#### AGENDA STAFF REPORT

SUBJECT: Approve Second Amendment to Fixed Base Operator Lease with Clay Lacy Aviation

4. Approve and execute Second Amendment to the Fixed Based Operator Lease with Clay Lacy Aviation, Inc. to modify the site plan for the Northwest parcel.

### **Conceptual Plans**

### **EXHIBIT F**

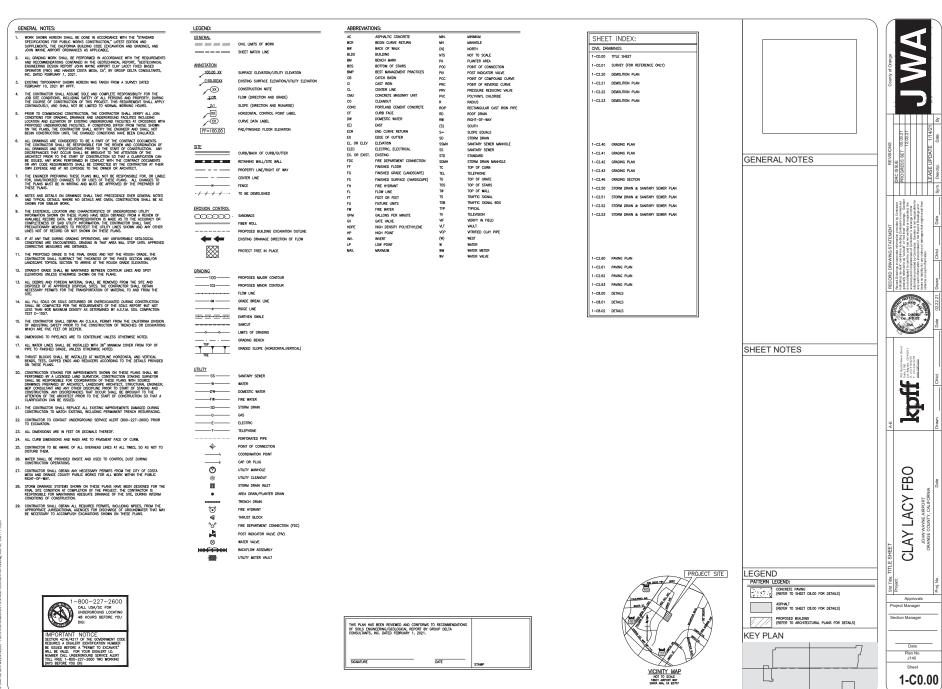
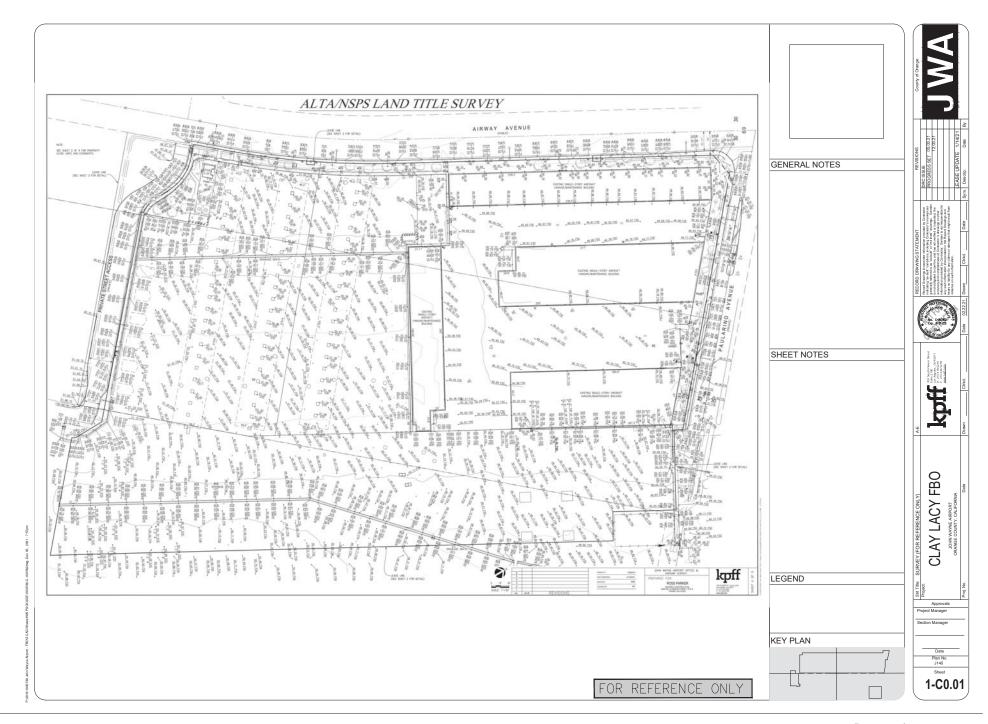
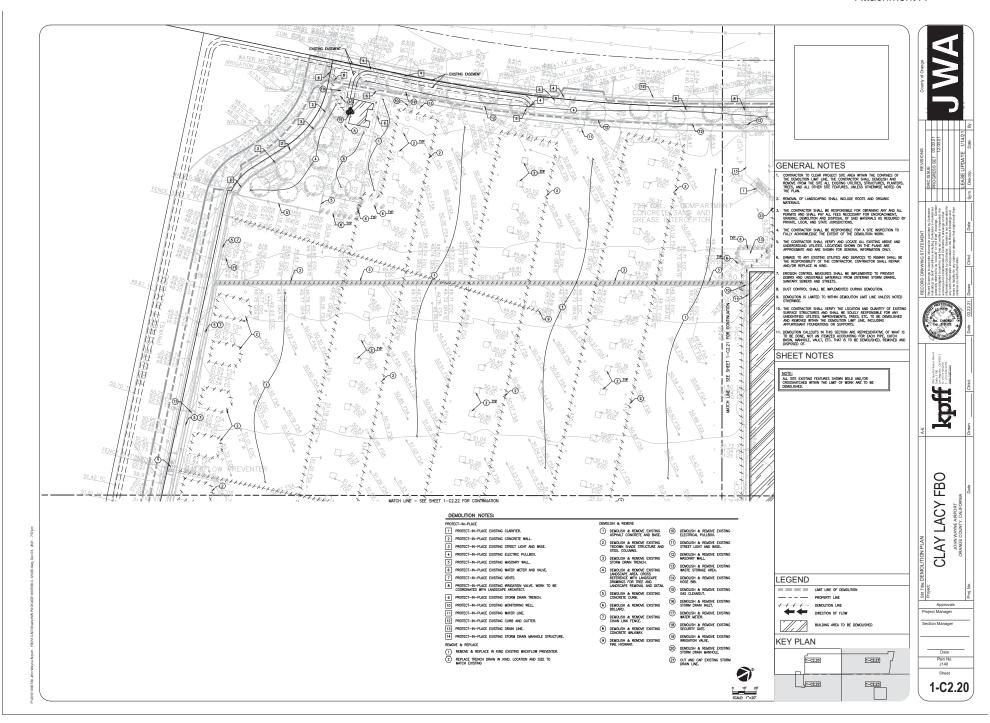
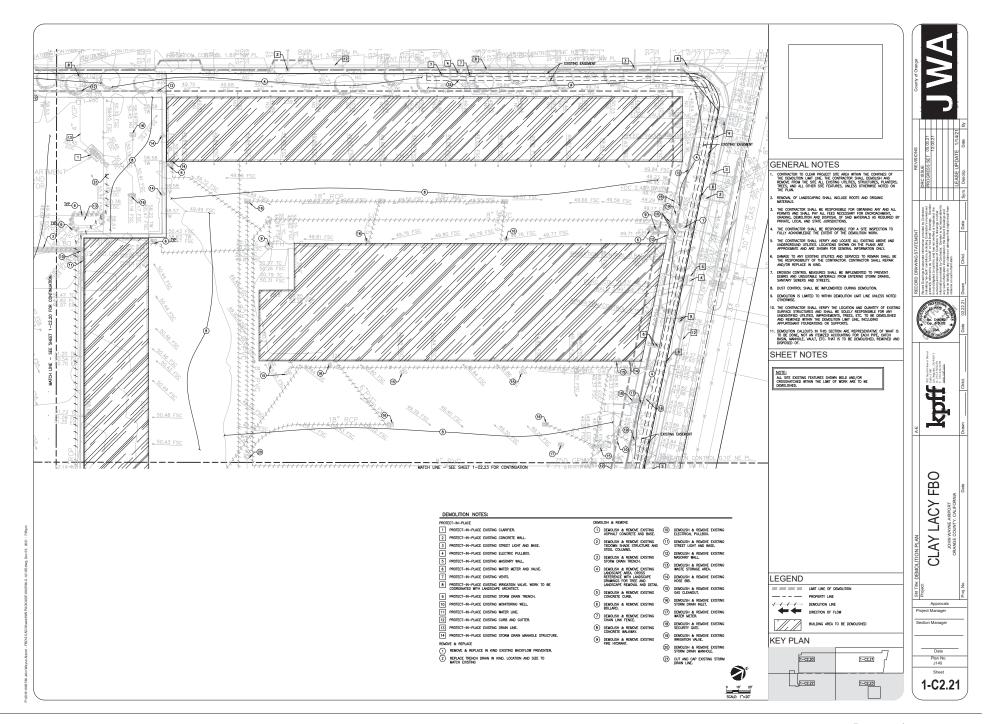
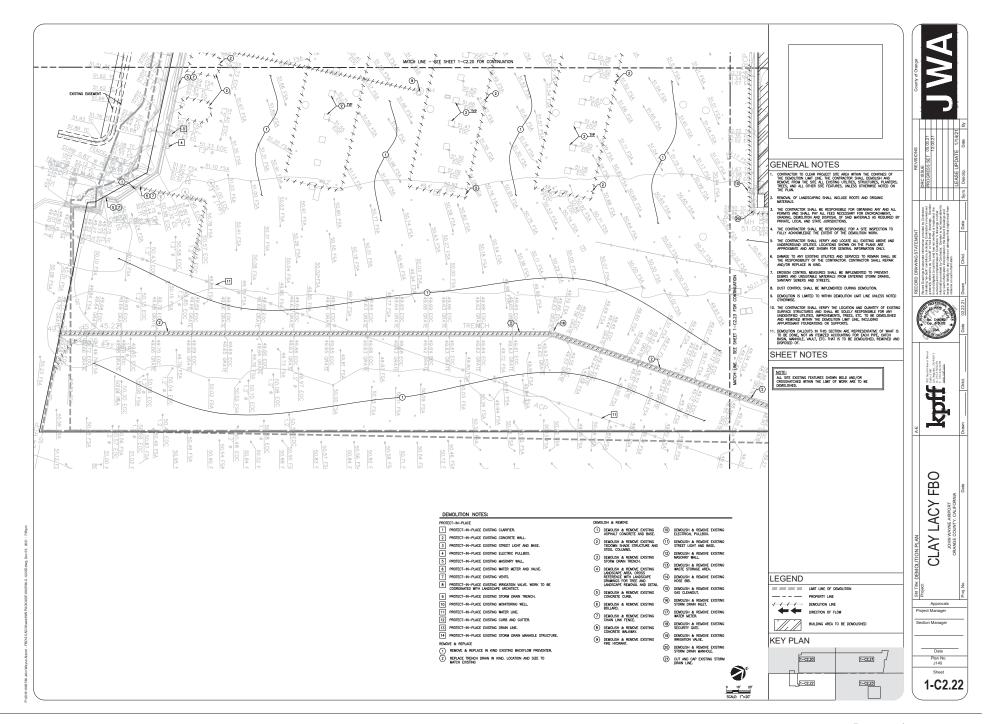
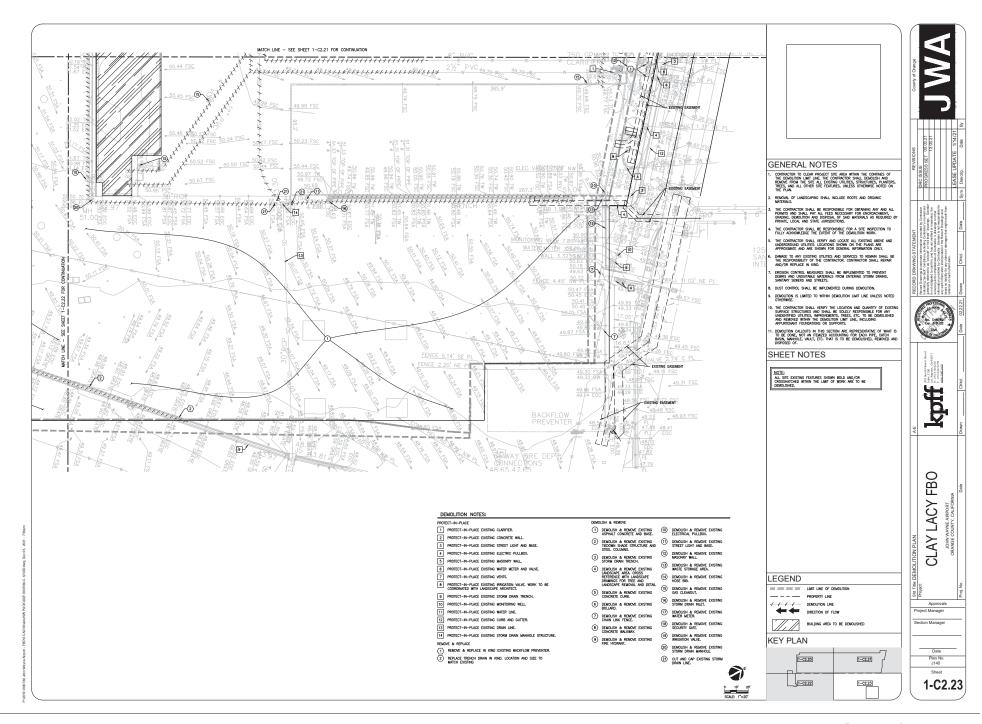
WHEREAS, LESSEE indicates that its conceptual plans set forth in Exhibit F require modification due to a reduction in space allotted to the Orange County Sheriff's Department's Air Support Facility; and

- A. Exhibit F, "Conceptual Plans," is hereby deleted and replaced in its entirety with Exhibit F attached hereto and incorporated herein by reference.
- B. This Second Amendment sets forth all of the agreements and understandings of the parties with regard to its subject matter and any modification must be in writing and properly executed by both parties.
- C. All other terms and conditions of the FBO Lease, as amended, shall remain unchanged and in full force and effect.

After approval of the Clay Lacy FBO lease by the County, OCSD indicated that they do not need the amount of space that was identified in FEIR 627 and the approved Clay Lacy lease. FEIR 627 identified five buildings on the Northwest FBO leasehold: three community hangars, an FBO office/terminal, and a combined hangar/office for OCSD. Since OCSD no longer requires as much space as previously identified in FEIR 627 and the approved lease, the OCSD hangar/office has been incorporated into a new community hangar. The modified Clay Lacy FBO site plan proposes five buildings in slightly different configurations and sizes than was shown in the approved Clay Lacy lease to accommodate the change in OCSD needs.

After reviewing the economic feasibility of various development options, the modified Clay Lacy FBO site plan contains the following components (**Exhibit 1**):

TABLE 1					
Comparison of Previously Approved Clay Lacy FBO vs. Modified Clay Lacy FBO					
Item	Previous Clay Lacy FBO	Modified Clay Lacy FBO			
Community Hangars	99,000 sf	128,545 sf			
OCSD Hangar (with attached OCSD Office)	26,544 sf	16,200 sf			
FBO Apron	270,270 sf	240,307 sf			
OCSD Apron	30,000 sf	31,000 sf			
GSE Dedicated Space	*	21,300 sf			
FBO office space	19,994 sf	24,000 sf			
Hangar Office Space	7,600 sf	17,800 sf			
# Vehicle Parking Spaces	277	263			
sf = square feet					
* GSE included in overall FBO apron total
